President and Board of Trustees
Village of Arlington Heights
Board Room

October 19, 2015

Item: Ordinance - Chapter 28 Variation - Holy Nation Presbyterian Church

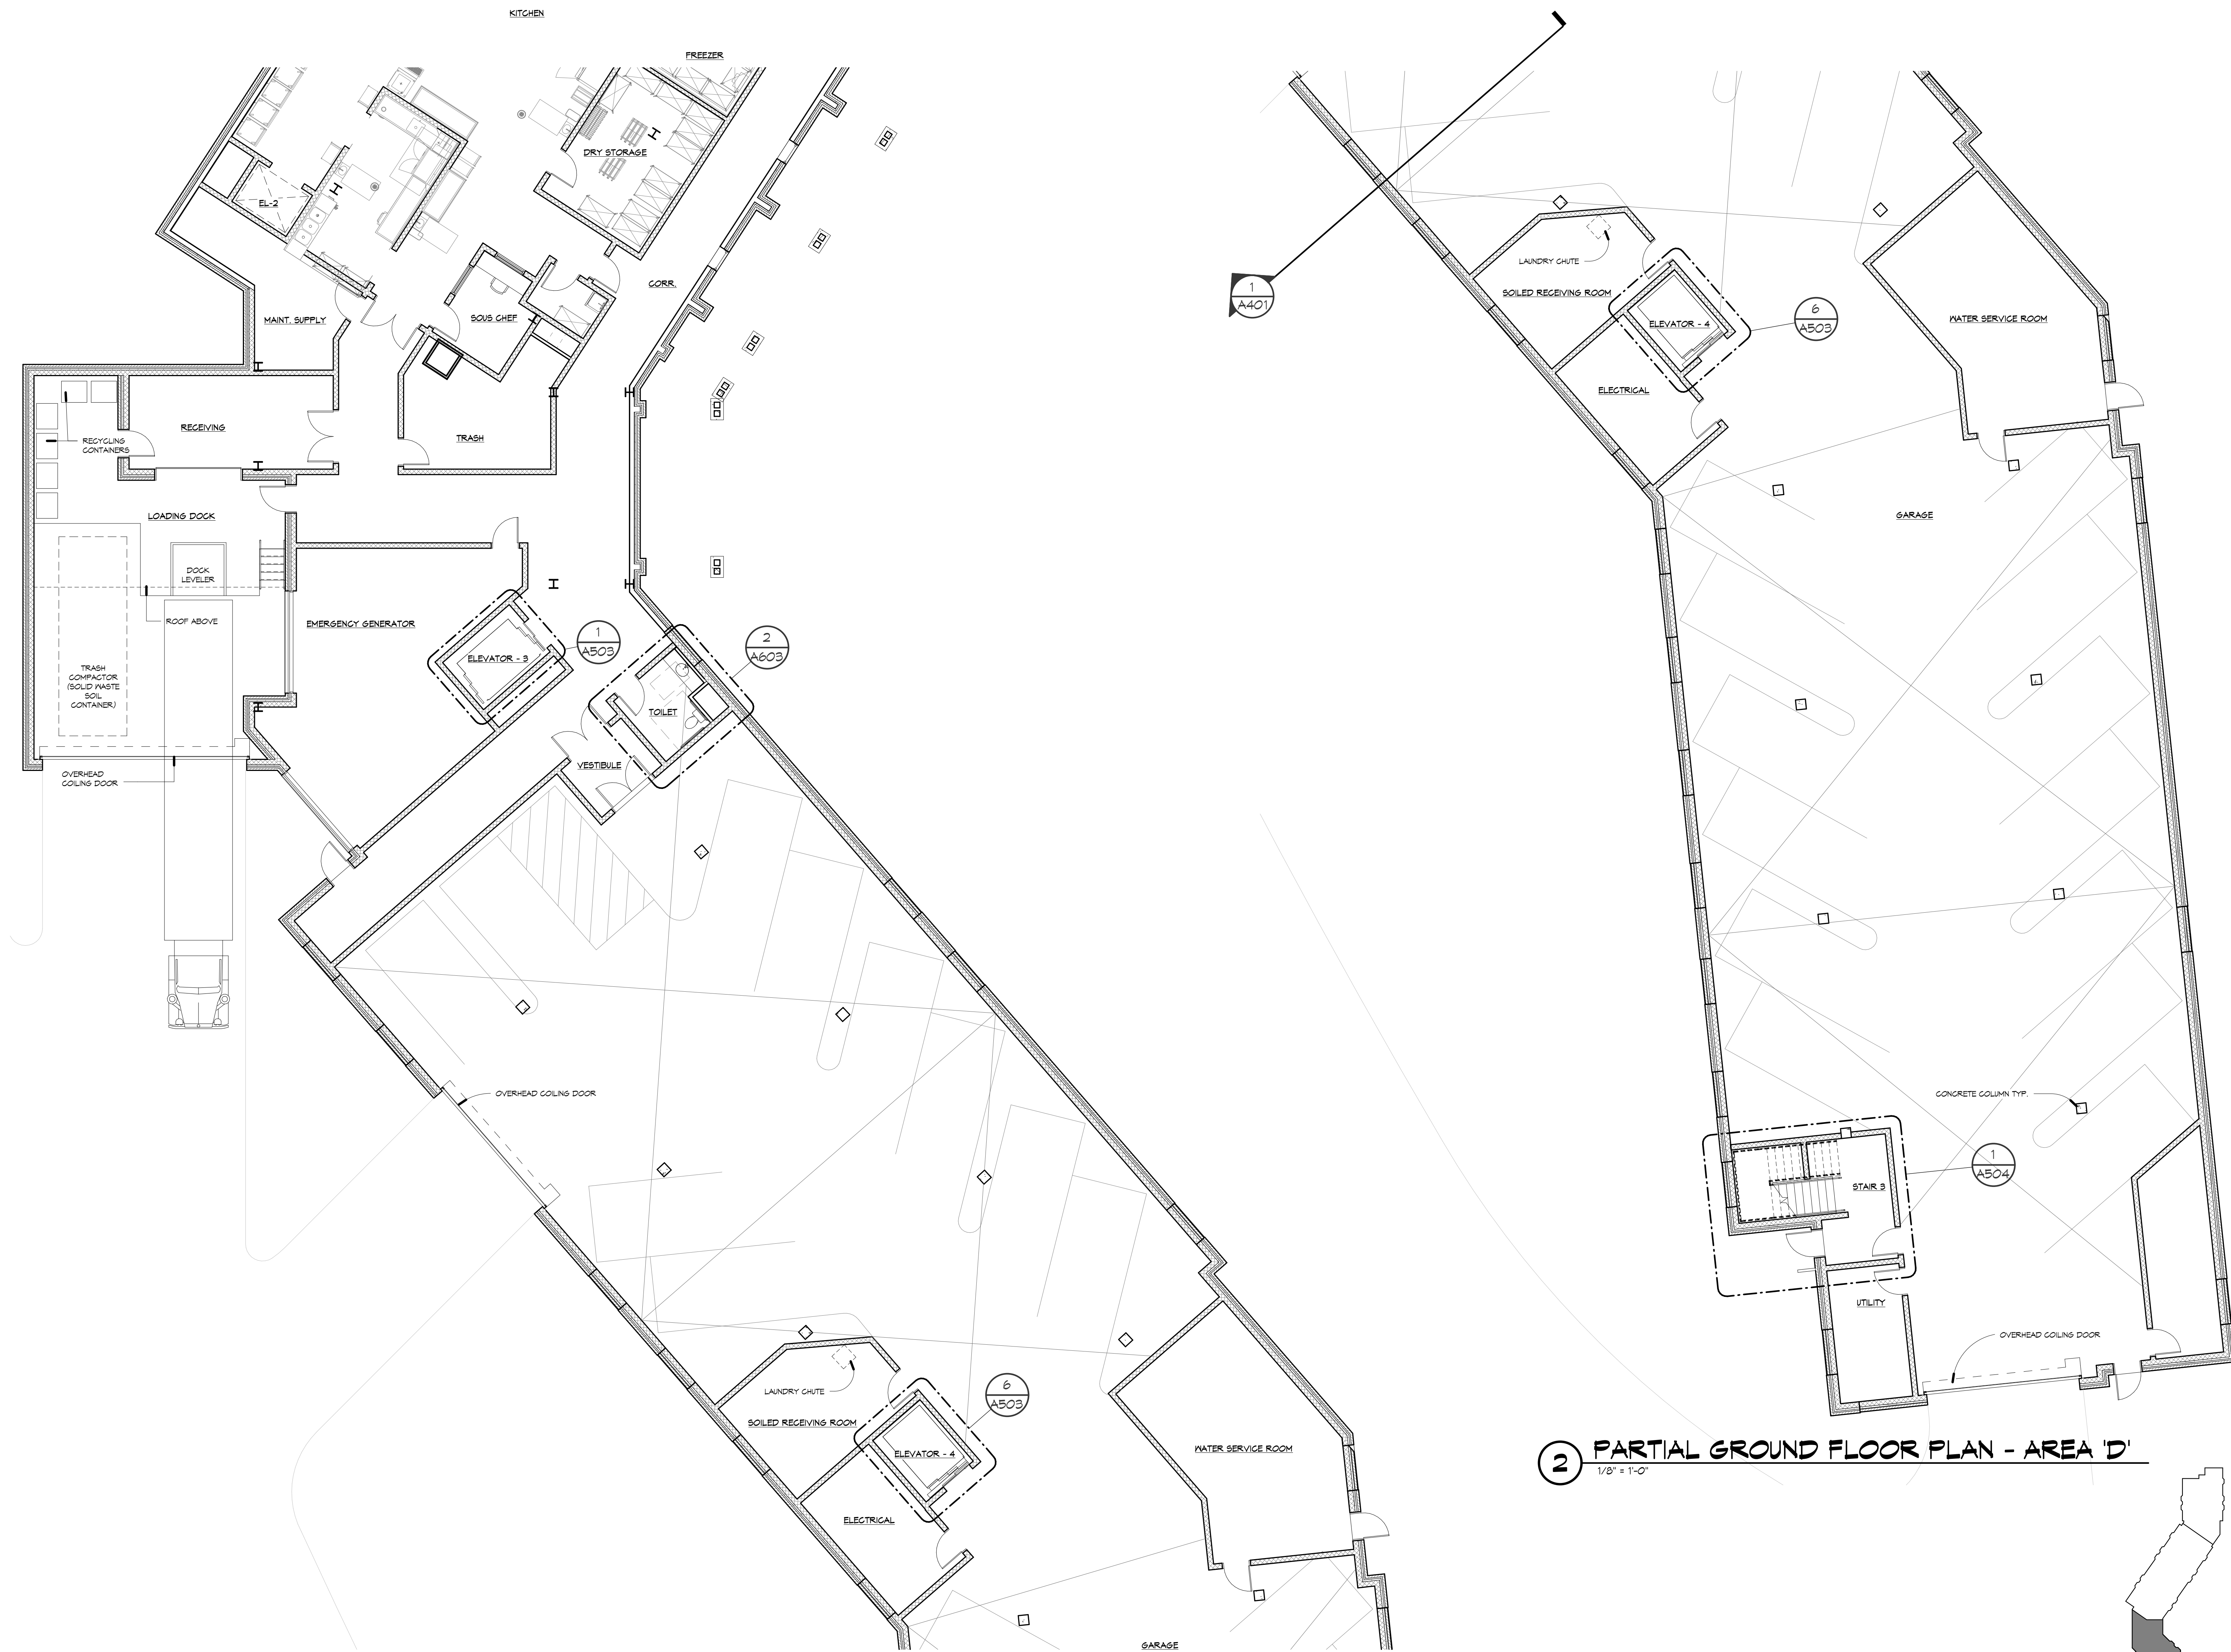
19. Sheet A002, Ground Floor Plan: When backing out of the first underground parking space, the garage door will need to open.

17. The restrictor plate detail has been revised to show a concrete baffle wall. See sheet C7.0.
18. No response required.
19. The garage plan has been revised. See attached Assisted Living drawing A102.

1. There is a solid waste soil container (compactor) included in the dock area. We've included an updated drawing noting this location. See Assisted Living drawing A102
 - a.) The area accommodates the compactor selected by the owner.
 - b.) The location of the container is in the dock area. The surface is concrete. The area slopes to a linear drain.
 - c.) The dock area is fully enclosed by walls and an overhead door.
2.
 - a.) There is sufficient space for a truck to access this area.
 - b.) This container is in the dock area. Sufficient clearance is provided for access vehicles.

22. The loading berth is provided in the Assisted Living building. See attached Assisted Living drawing A102.

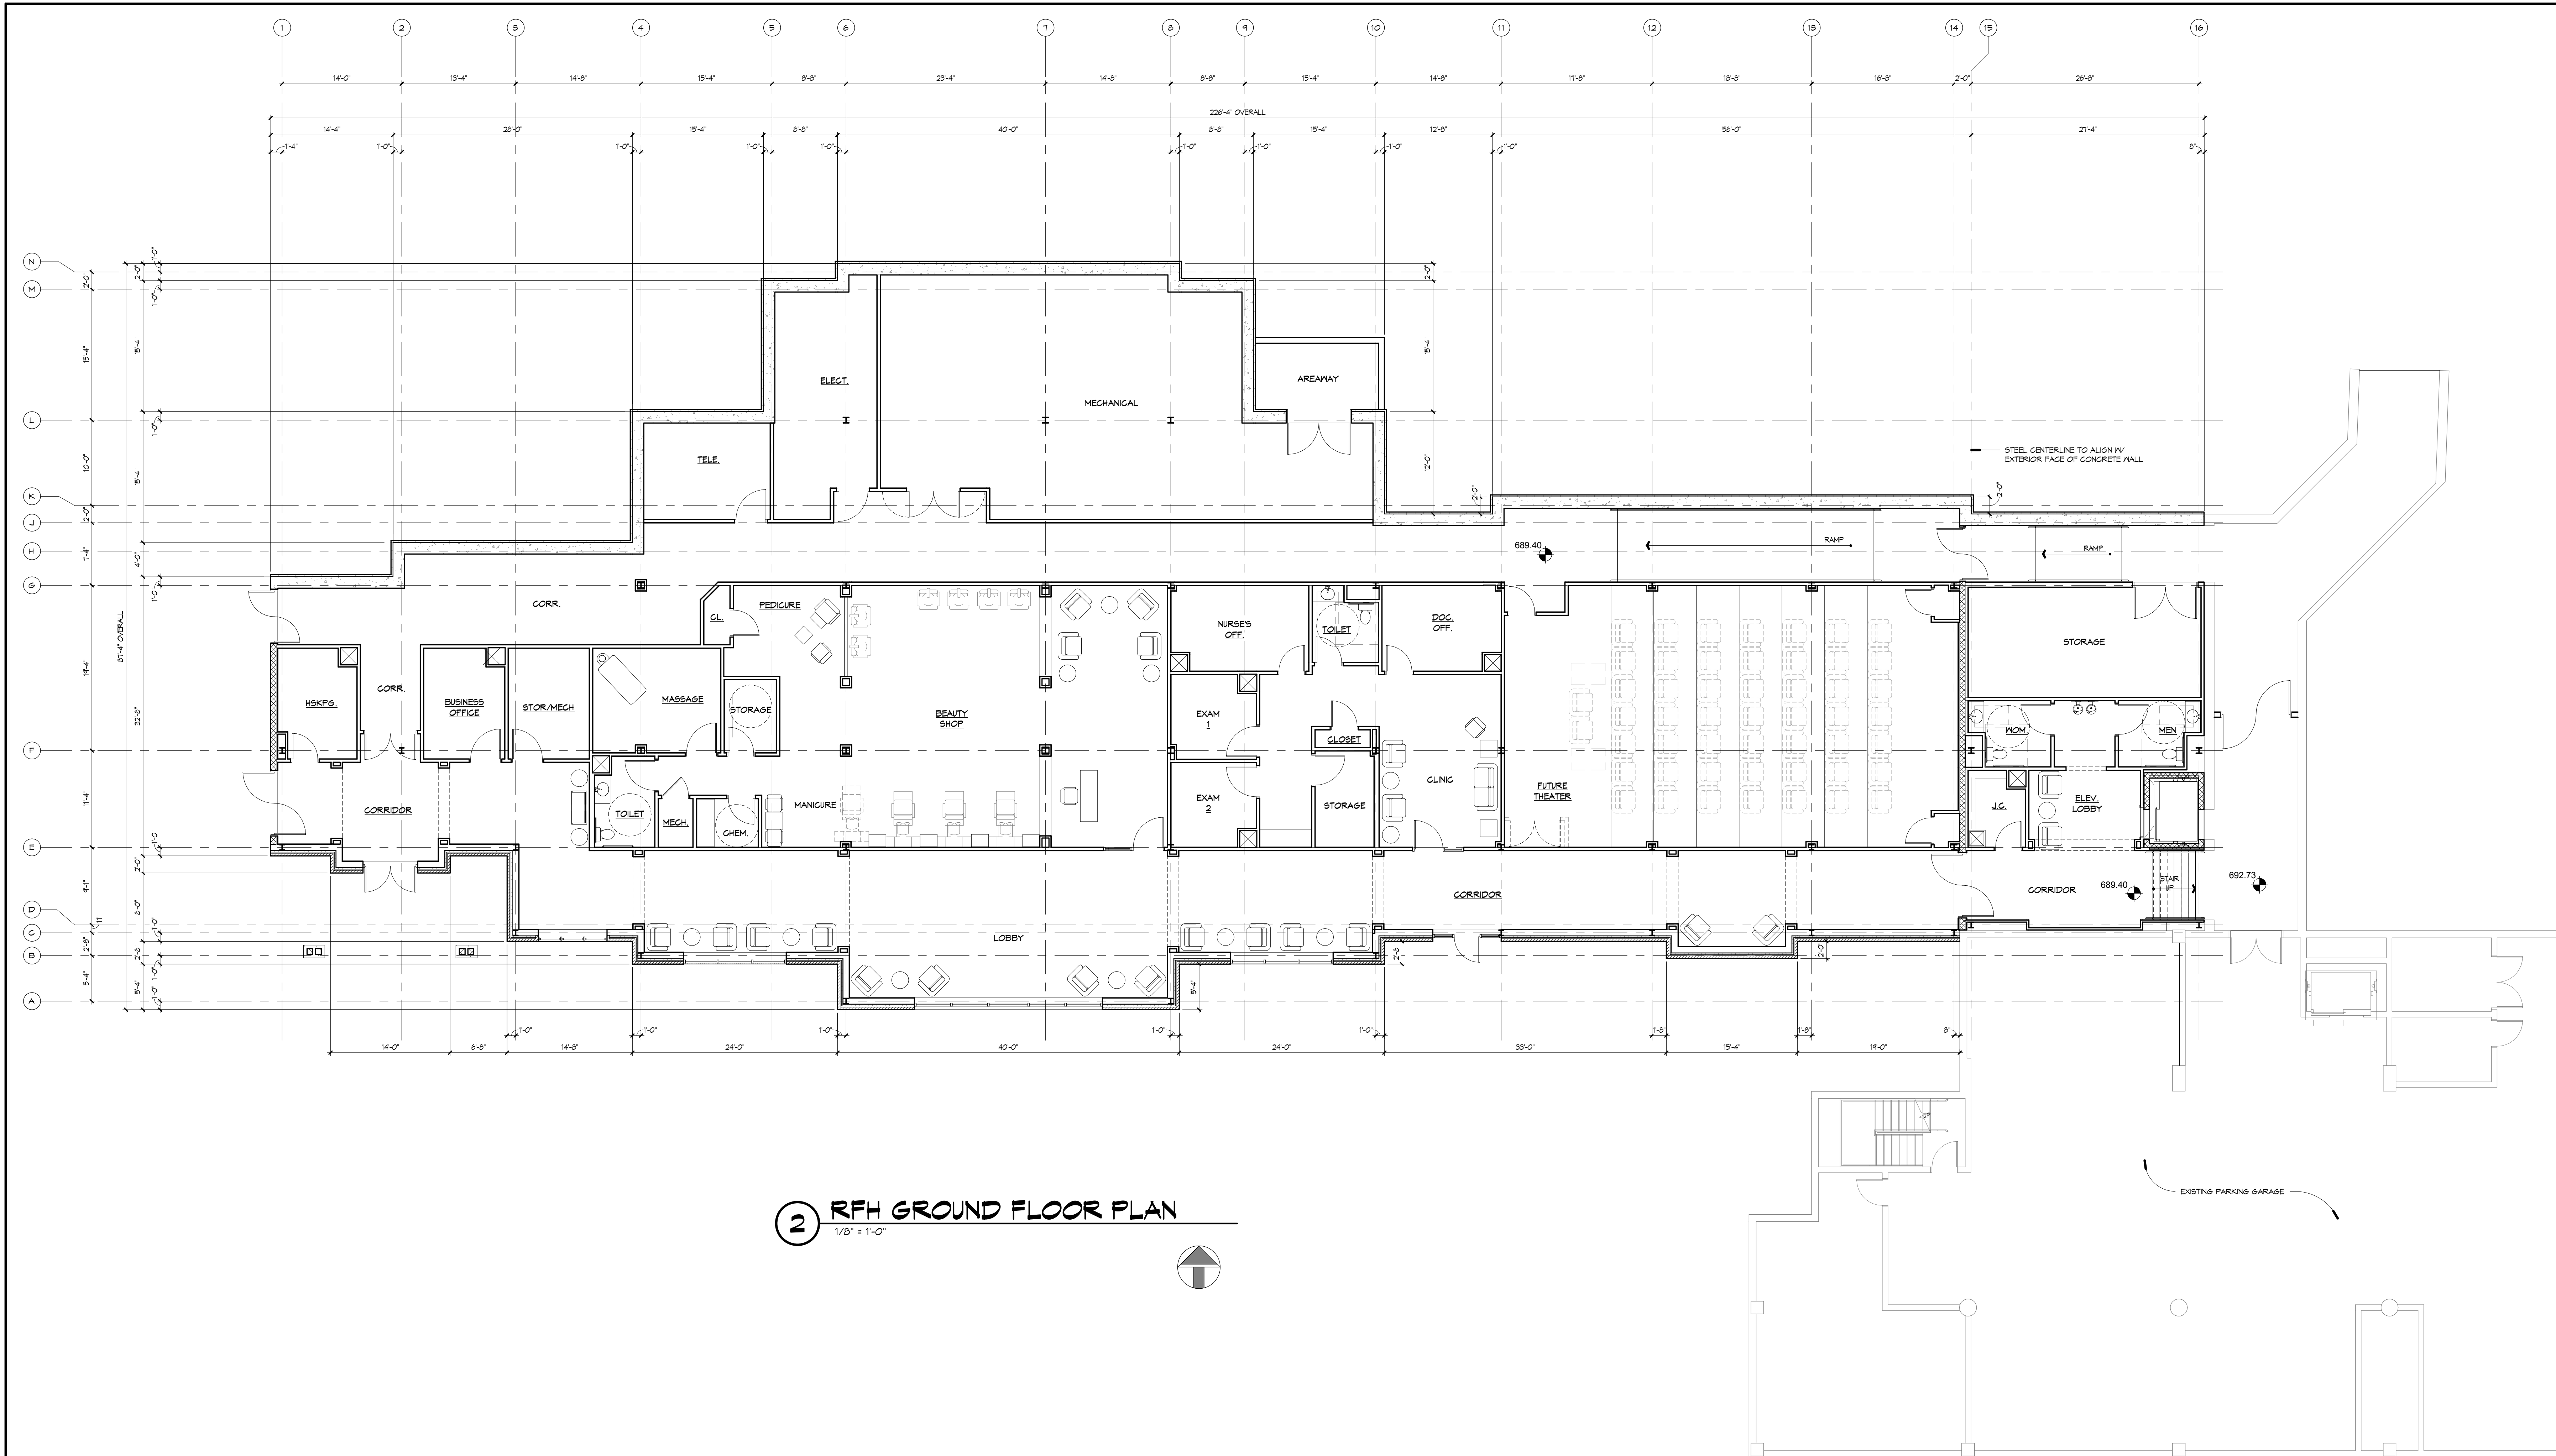
3. In the Men's and Women's Locker Rooms the wheelchair accessible "Standard Stall" door shall open opposite the clear floor space to allow adequate wheelchair maneuvering space within the stall, per IAC Section 400.Illustration B. Figure 30(a).

1. The plans have been modified to to provide required clearance. See attached Resident Fellowship Hall drawing A101.
2. The stalls have been modified to provide required clearances. See attached Resident Fellowship Hall drawing A102.
3. The stalls have been modified to provide required clearances. See attached Assisted Living drawing A101.
